SERVICE BULLETIN

APPLICABILITY: 2015-2017MY WRX 2.0L DIT Models

NUMBER: 03-78-17

SUBJECT: Clutch Release Bearing- Design Change

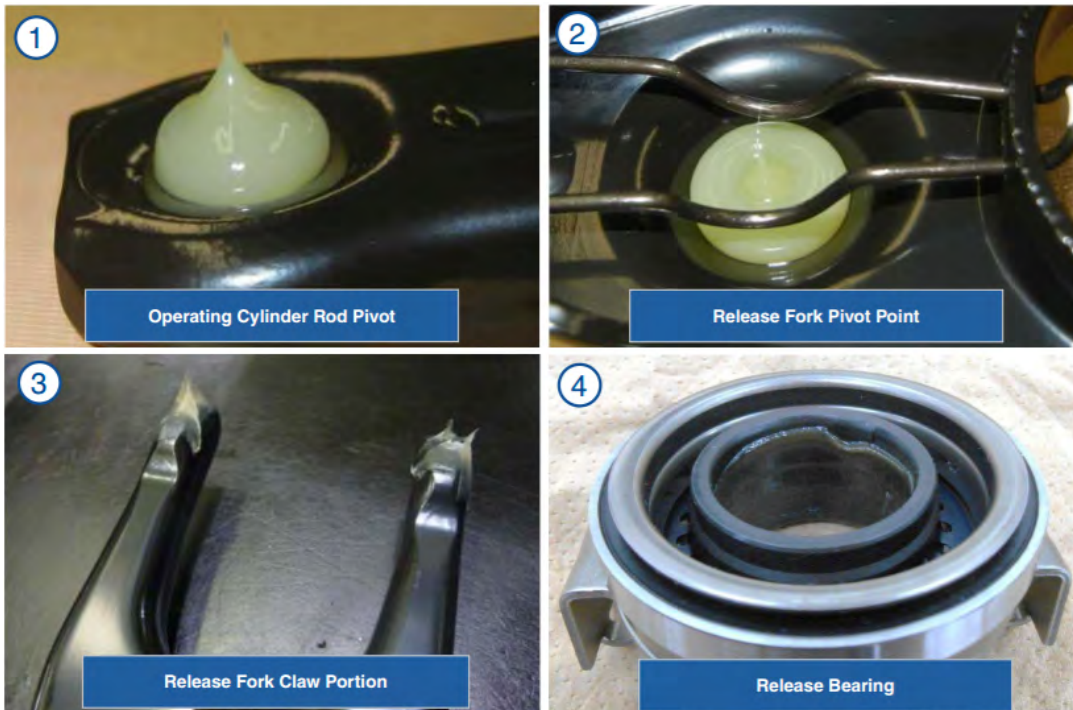
The part number for the new clutch release bearing is: **30502AA160**. The photos below show the differences between the old and new-style parts. The shape of the outer race has been changed.

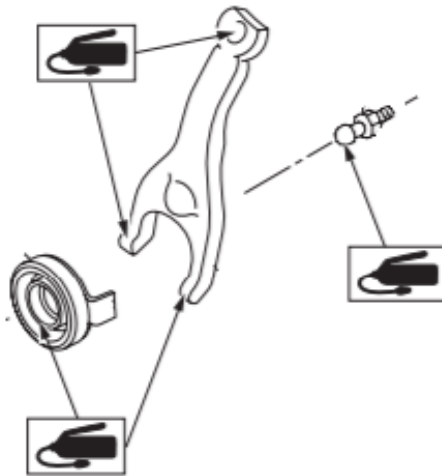
- Always inspect for any excessive or abnormal wear on the release fork pivot point, operating cylinder rod and release lever pivot points, and the pivot ball.
- Always use the proper grease (Nichimoly N-130, Conoco-Philips Multiplex Red #2 or Subaru p.n. 000041000) when lubricating the contact points of the release bearing and related components as specified in the Service Manual and shown below.
